**STAFF RECOMMENDATION**

**CASE FILE NO.:** Z0492-19-D

**PROPOSAL:** Construction of three new self-storage buildings totaling approximately 129,100 square feet, along with a leasing center and caretakers residences. Proposed project also includes revisions to site access, circulation, parking, landscaping, and other redevelopment as required by the Clackamas County Zoning and Development Ordinance.

# Site Plan

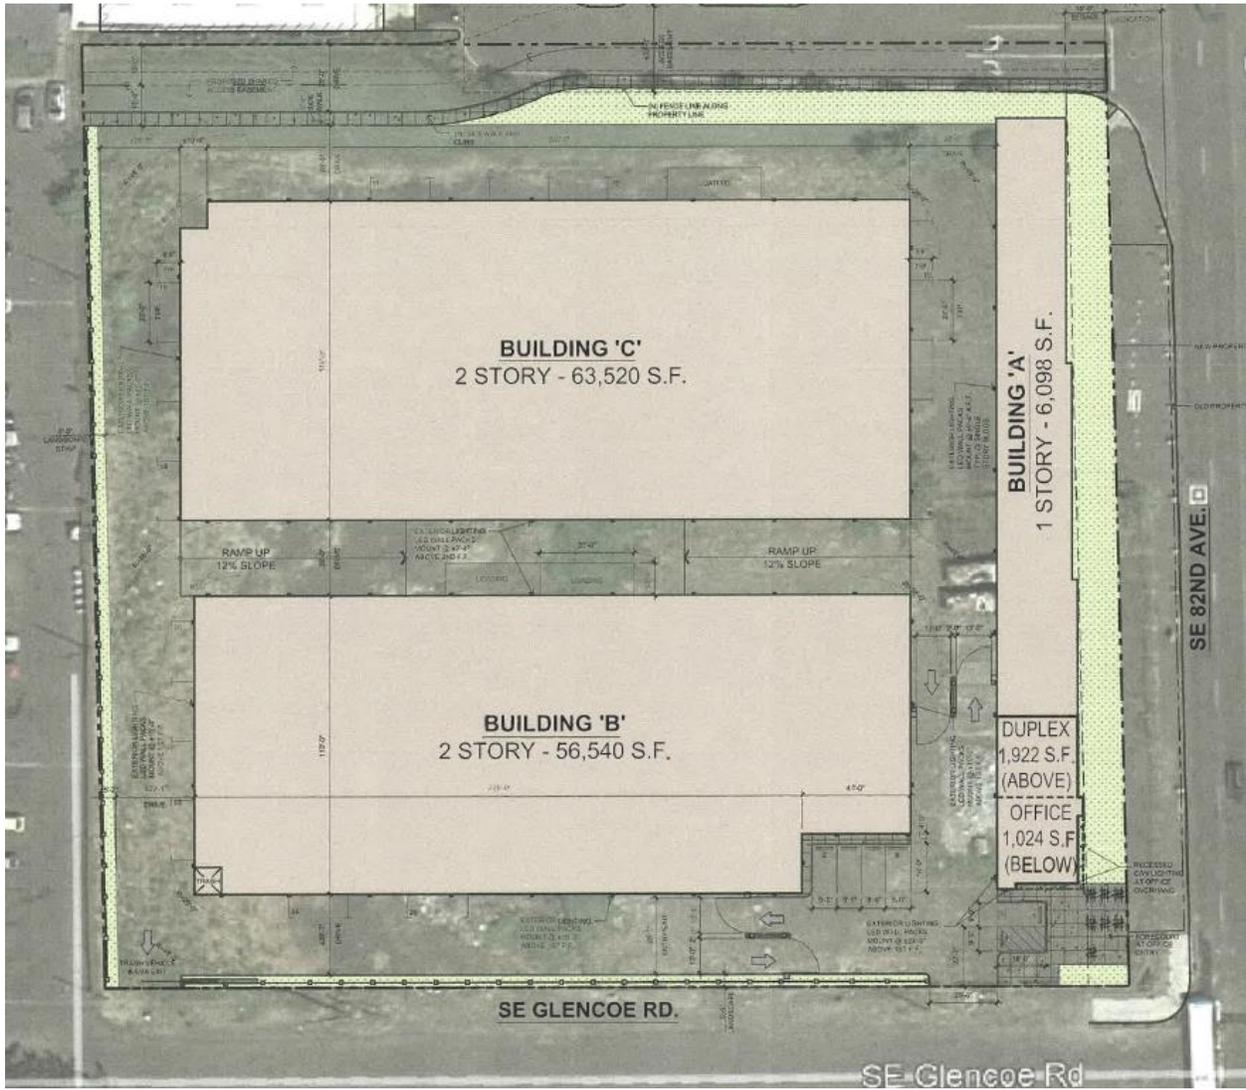
10. Per *Clackamas County Roadway Standards Clackamas County Roadway Standards* chapter 3 and ZDO Sections 1007.01 through 1007.03, the applicant shall meet the access and driveway requirements for the site. The proposed site driveway is located toward the east property line approximately 50 feet west of the proposed SE 82<sup>nd</sup> Avenue right of way. There is a secondary access proposed for emergency and waste management vehicles approximately 300 west of the main access drive. The proposed access locations meet the minimum required spacing for a local road. Due to the intersection of Highway 213 and Glencoe Road being identified as an ODOT STIP project, it is recommended that the access drive be shifted farther to the west to allow a greater distance from the intersection.

The minimum commercial driveway width is 28-ft. The minimum driveway throat length is 20-ft. Based on the low traffic volumes anticipated to use the site, the east-west access drive closest to the driveway approaches will be allowed. The parking at the main entrance, however, shall meet the requirements for the minimum driveway throat length in order to prevent conflicts between vehicles maneuvering for parking and vehicles entering or exiting the site.

- e. Minimum 28-foot wide concrete driveway approaches, per Standard Drawing D600. The driveway approach shall intersect the road at an 80-90 degree angle, per Roadway Standards Section 250.8.2.

- f. The applicant shall provide and maintain adequate sight lines for minimum intersection sight distance of 280 feet at the driveway intersection with SE Glencoe Road

## Building Elevations

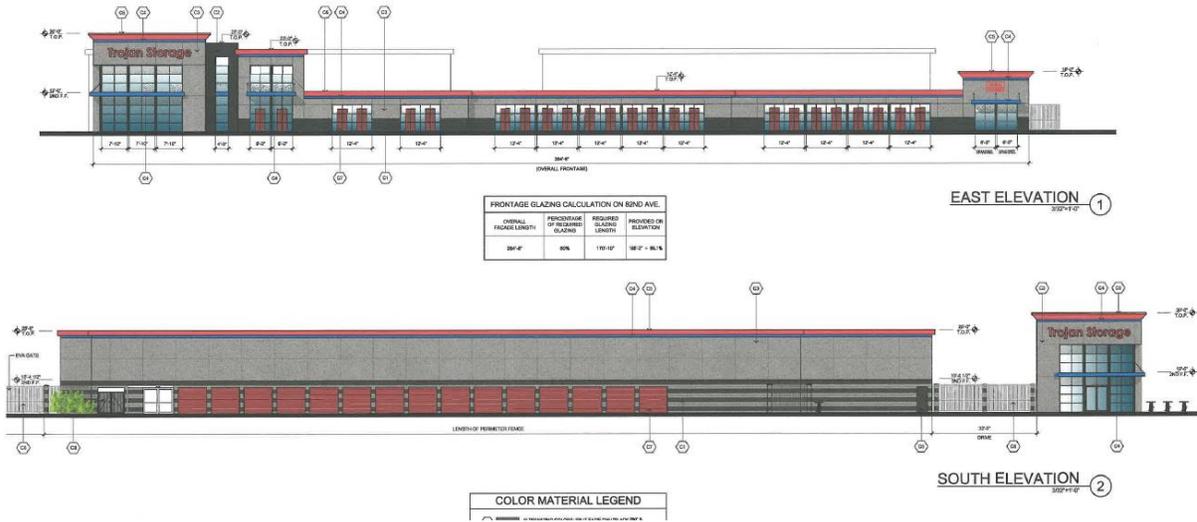
**Finding:** The building is designed with articulation of the façade through fenestration, change in materials and color, and modulation of plane. Human scale and proportion is used in the placement of materials with smaller scale materials and additional and texture closer to the ground plane. Additionally, the primary public entrance (to the leasing office) has a 4 foot projecting canopy for weather protection. Additional building height at the corner of SE 82<sup>nd</sup> and Glencoe gives additional prominence to the public entrance and a design feature marking the intersection of the two public streets. The design uses colors that are appropriate to the commercial context. The design of the building is consistent with its proposed use and level of public exposure. The façade materials are
